Summary of Comments
Pertaining to SFM Wildfire Protection Building Standards
Provided to the
CBSC Building Fire Other Code Advisory Committee

AUGUST 10, 2009

Written Participation Comments
Pertaining to Wildfire Protection Building Standards
"CBC Ch7A" Comment # 1A
THORNBERRY
Submitted to the
CBSC Building Fire & Other Code Advisory Committee
2525 NATOMAS PARK DRIVE, COUNCIL RM. SUITE 120
SACRAMENTO, CA 95833
10:00 A.M. AUGUST 10, 2009
E. Foote OSFM

Firebrand passing through screen

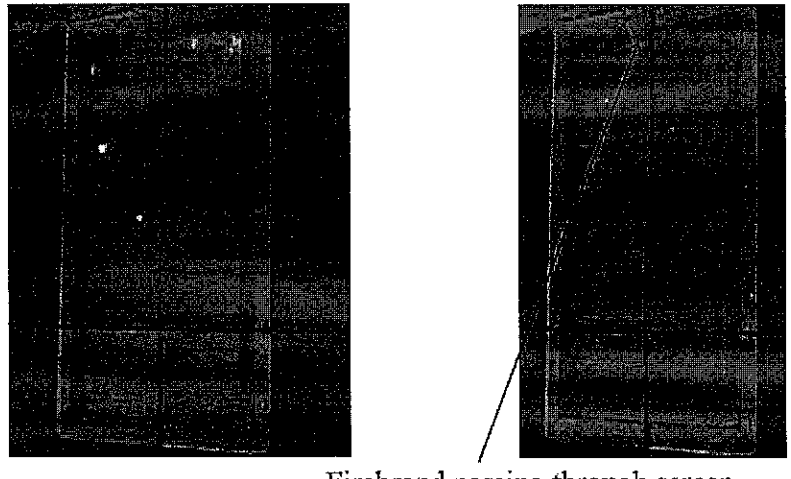
- MESH IS NOT ENOUGH!-

- ***"The firebrands were not quenched by the presence 1/8" screen and would continue to burn until they were small enough to fit through the screen opening. <u>For all screen sizes tested</u>, the firebrands were observed to penetrate the screen and produce a self-sustaining, smoldering ignition inside the paper beds installed inside the structure."***

- Why the change to allow 1/8" mesh in the face of so much data that shows it does nothing to protect against flames and embers?
- Why doesn't he current document address through roof and other exterior wall vents?
- What data was used to justify the change to the code language?
